**REGULATION No. 12**  
**(Steering wheel)**

**Proposal for Corrigendum 2 to Revision 3 of Regulation No. 12**

**Submitted by the expert from Japan \*/**

"Annex 4  
BODY BLOCK

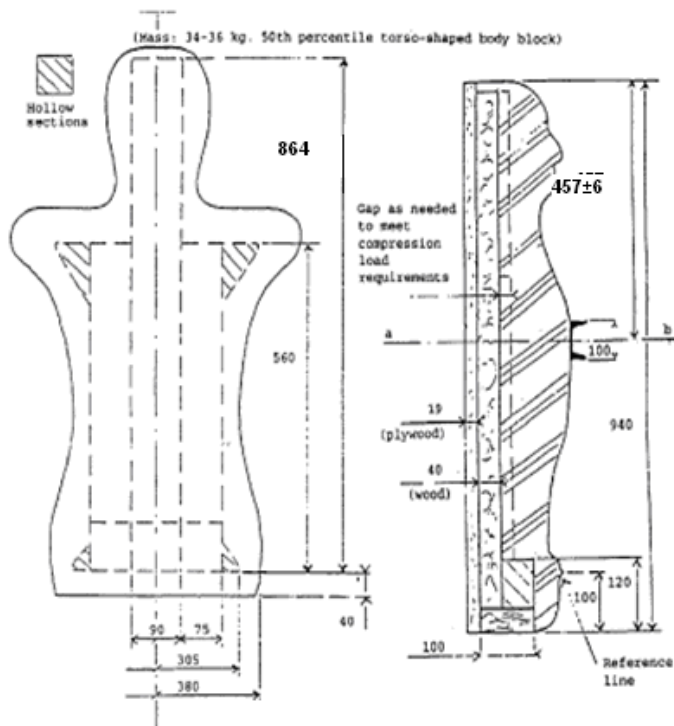
The text reproduced below was prepared by the expert from Japan in order to correct clerical errors in unit conversion from "inch" to "centimeters" of the body block dimensions. It is based on a document without symbol (informal document No. GRSP-44-12) distributed during the forty-fourth session of the Working Party on Passive Safety (GRSP). The modifications to the existing text of Regulation No. 12 are marked in bold.

Annex 4, appendix, amend to read:

The dimension of Body Block is internationally based on the SAE standard J944 JUN80. However, the dimensions for the above two parts specified in SAE J944 JUN80 are different between "inch" and "centimeter" units. These are clerical errors in unit conversion from "inch" to "centimeters", and these dimensions should be read as  $18 \pm 0.25$  inch = **457 ± 6 mm** and 34 inch = **864 mm** respectively. Since Regulation No. 12 incorporates the dimensions misconverted in SAE standard, therefore those errors should be corrected.
